Reliability Analysis Update

Sub Regional RTEP Committee - PJM West

July 16, 2021

Replace B3278.1 (Presented in 12/18/2020 and 2/17/2021 SR RTEP)
With B3278.3

B3278.3: Saltville Station: Install two breakers and bus diff protection.

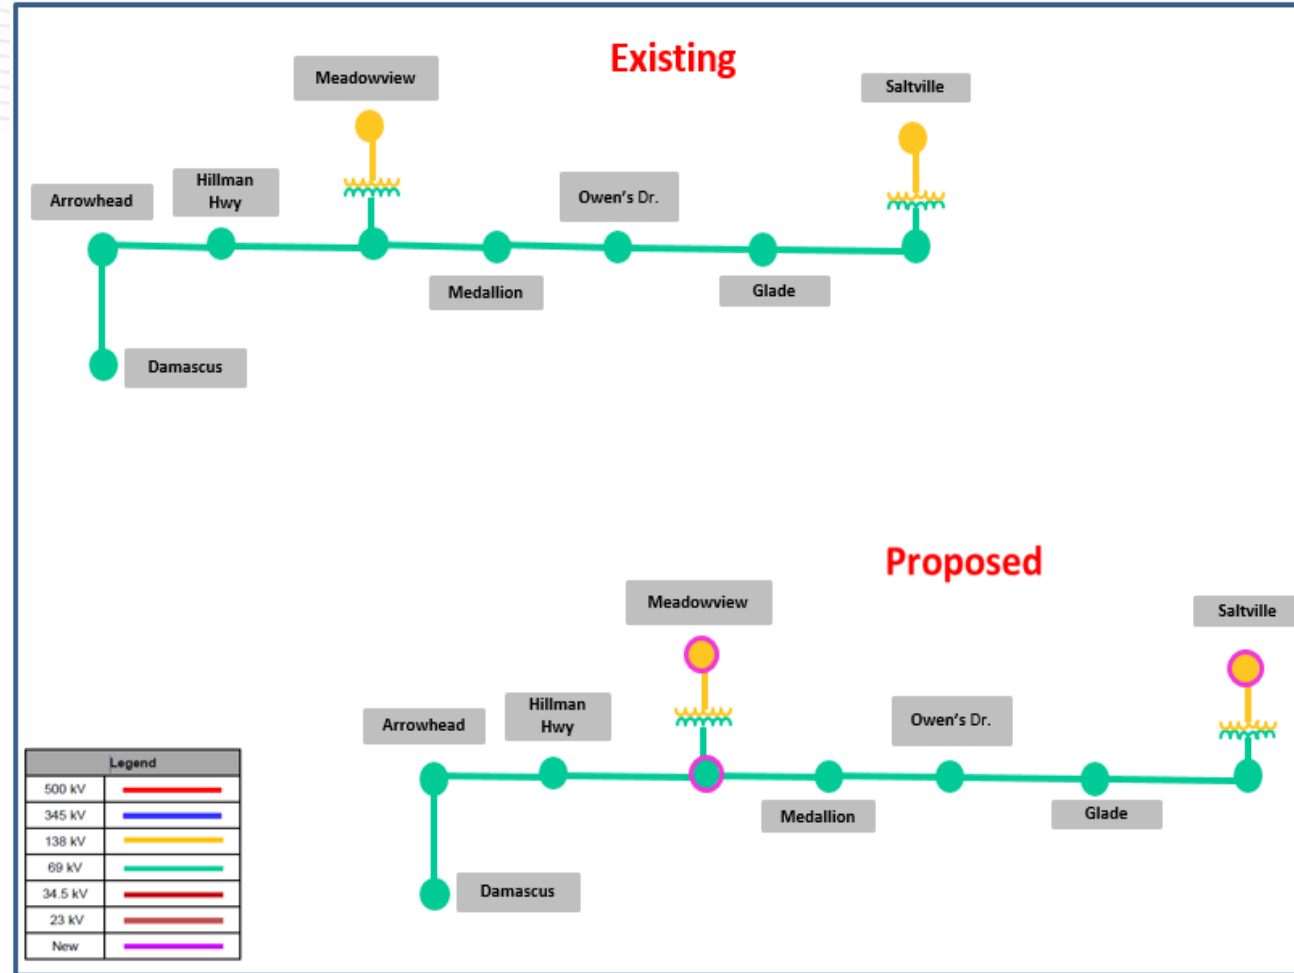
B3278.1: Saltville Station: Replace H.S. MOAB Switches on the high side of the 138/69-34.5 kV T1 with a H.S. Circuit Switcher.

Reason for the scope change: AEP-2020-AP037 and AEP-2021-AP004 solution, that requires reconfiguring Saltville station into a breaker-and-a-half arrangement, would eliminate the need for the switcher. By replacing the switcher with just the cost of the breakers that now protect the transformer, the same result is achieved.

NOTE: If the supplemental project is cancelled, B3278.3 will be cancelled and B3278.1 will be re-activated.

Estimated Cost: \$0.36M
